2010-15-09 Empresa Brasileira de Aeronautica S.A. (EMBRAER): Amendment 39-16375; Docket No. FAA-2010-0733; Directorate Identifier 2010-CE-038-AD.

(d) Air Transport Association of America (ATA) Code 30: Ice and Rain Protection.

Figure 3 – AFM Section 4-08, EMERGENCY BUS OFF

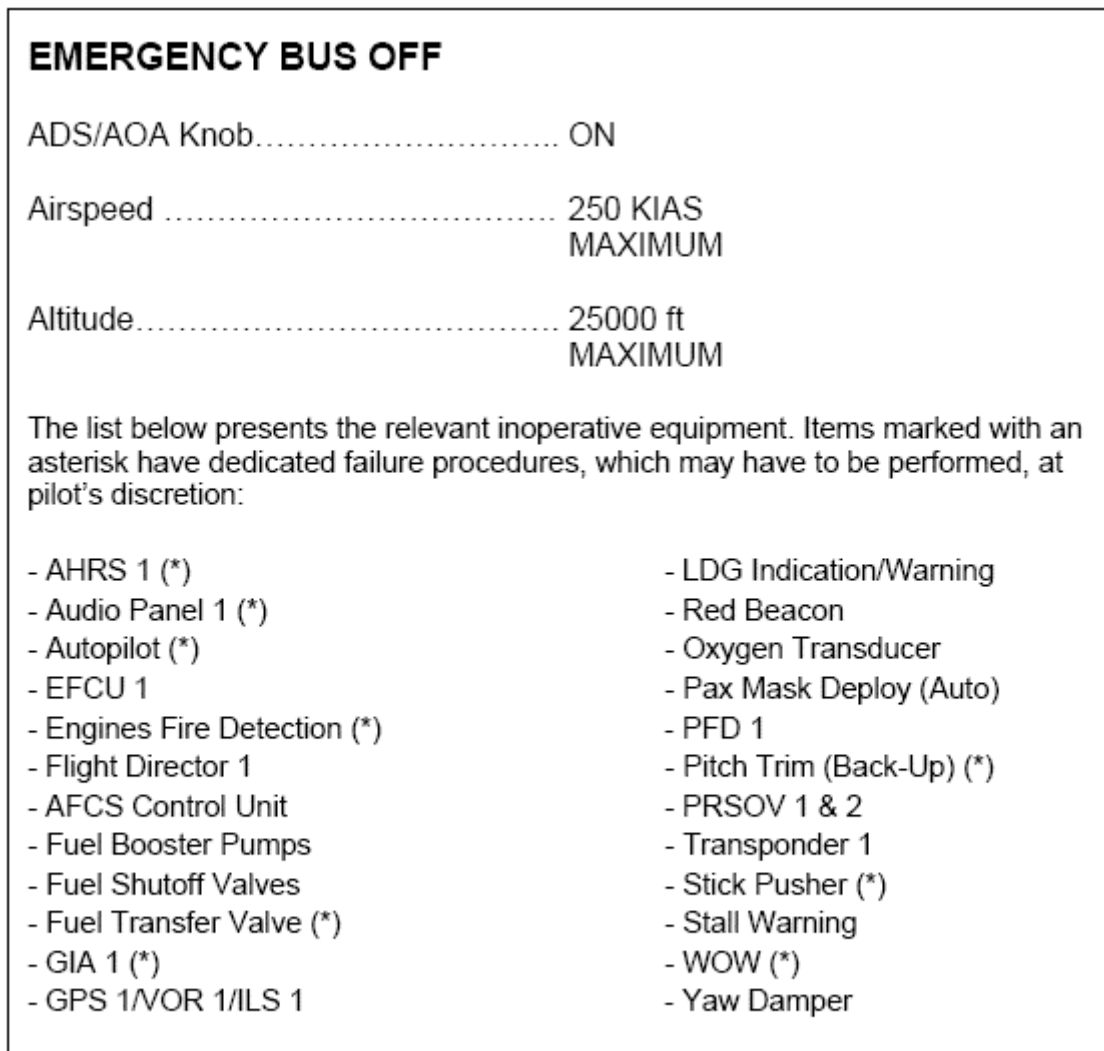
(3) Revise the AFM by replacing the EMERGENCY BUS OFF procedure in AFM section 4-08, Abnormal Procedures, with Figure 3:
